# METROPOLITAN GOVERNMENT OF NASHVILLE AND DAVIDSON COUNTY

## STAFF RECOMMENDATION 1113 Woodland Street August 15, 2012

**Application:** New construction – accessory building and Setback reduction  
**District:** Lockeland Springs-East End Neighborhood Conservation Zoning Overlay  
**Council District:** 06  
**Map and Parcel Number:** 08309014400  
**Applicant:** Bill Brimm & Andrew Krichels, owners  
**Project Lead:** Sean Alexander, sean.alexander@nashville.gov

Bill Brimm & Andrew Krichels  
1113 Woodland St. Nashville, TN 37206

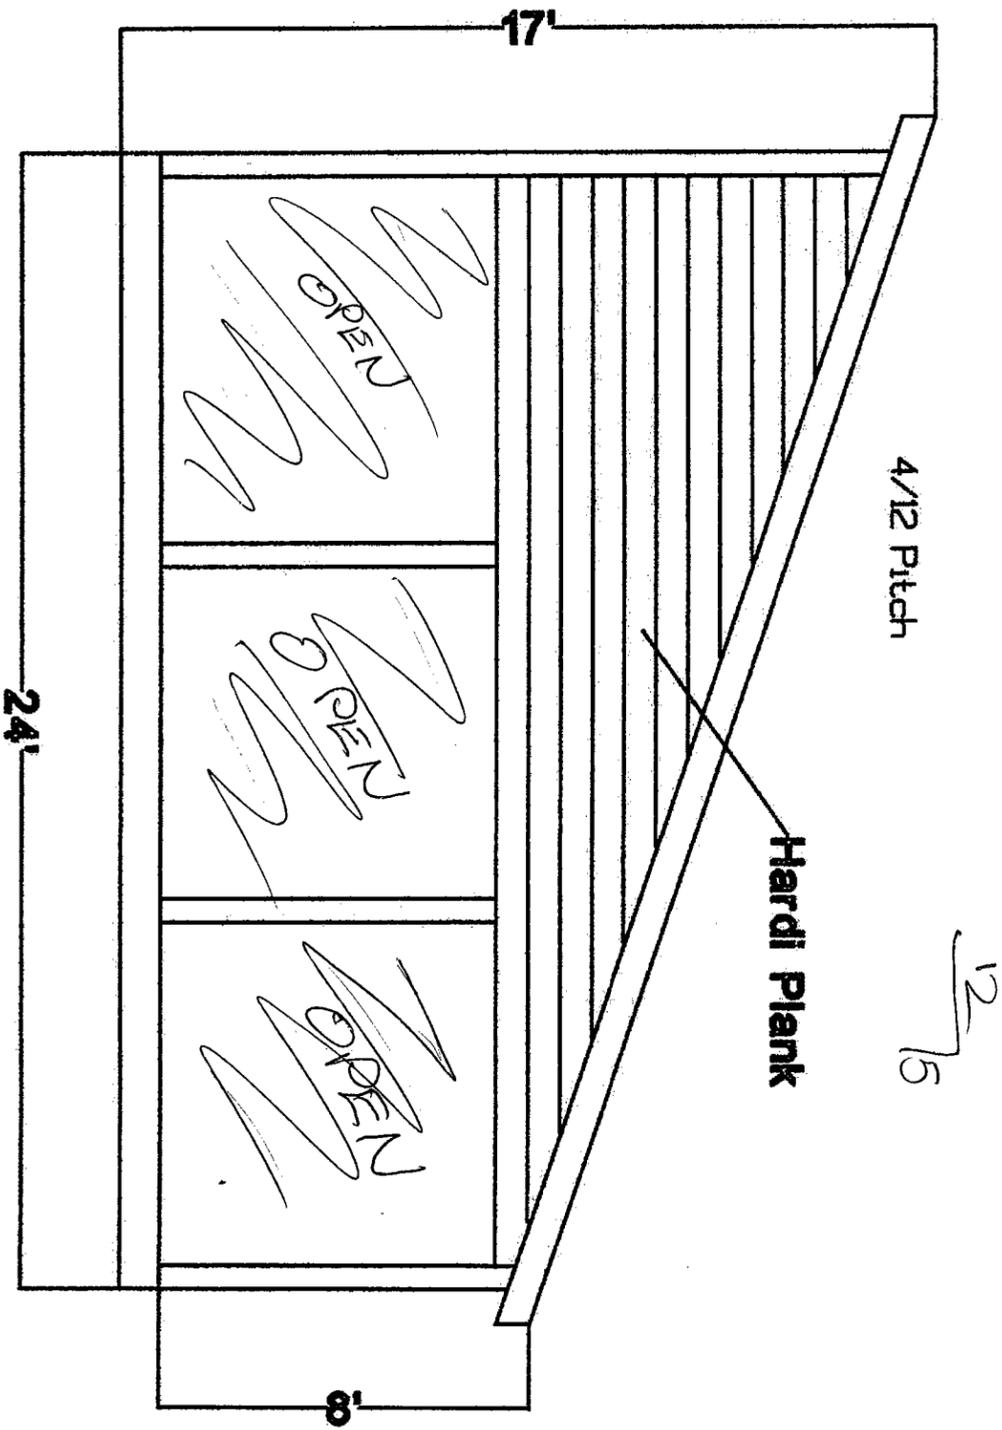
The building will be located nineteen feet (19') from the rear of the property and three feet (3') from the left side. This location will be visible from South 12<sup>th</sup> Street, and will require a reduction of the bulk-zoning setbacks. The current setbacks would be twenty feet (20') for the rear and five feet (5') on the side. However, staff finds the proposed building would be in a typical location of historic accessory buildings and meets guideline II.B.8.b. and II.B.8.c.

The roof of the building will be a rear-facing shed with a pitch between 4:12 and 5:12. This is a typical roof form for historic accessory buildings and is compatible with the roof of the primary building. The peak and front eave of the building will be seventeen feet (17") above grade, dropping to eight feet (8') tall at the rear. These heights meet guideline II.B.8.a.

The building will be constructed primarily of wood, with smooth cement-fiber siding in the upper walls, matching the exposure of the primary building. The lower half will be open with six inch (6”) square posts. The rear, alley facing wall will be cement-fiber siding with a metal vehicle door, and the roof will be asphalt shingles to match the primary building. These materials meet guideline II.B.8.a.

The structure will be accessed from the rear alley by a new concrete driveway. This location and material is appropriate and meets guideline II.B.9.

**Recommendation:** Staff recommends approval of the proposed new accessory building with reduced setbacks, finding it to meet the guidelines for accessory buildings in the Lockeland Springs-East End Neighborhood Conservation Zoning Overlay.
